To: Robert Lindgren
From: Pat O’Mahony, Associate Planner; 910-341-0189
CC: File;
Date: 11/28/2022
Re: 7-Eleven Market Street TRC Rev. 3

The following is a list of comments for review from planning regarding the project. Please provide your corrections as listed below. A staff summary of comments:

Landscape Plan:

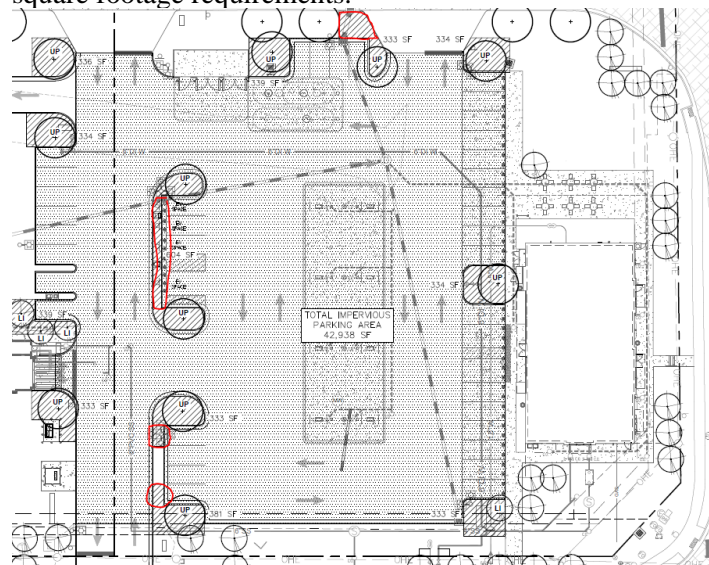
- Street trees (18-320)
 - Street trees are not shown in Birchwood Drive ROW.
- Parking lot shading requirement is 20%. The shading provided is in compliance, but the plans note 15% required on Sheet L2.2. Please update.
- Parking lot (18-321)
 - Show all landscape islands meet the minimum size of 333 sq ft.
 - Areas circled in red below cannot count towards to the landscaping square footage requirements.
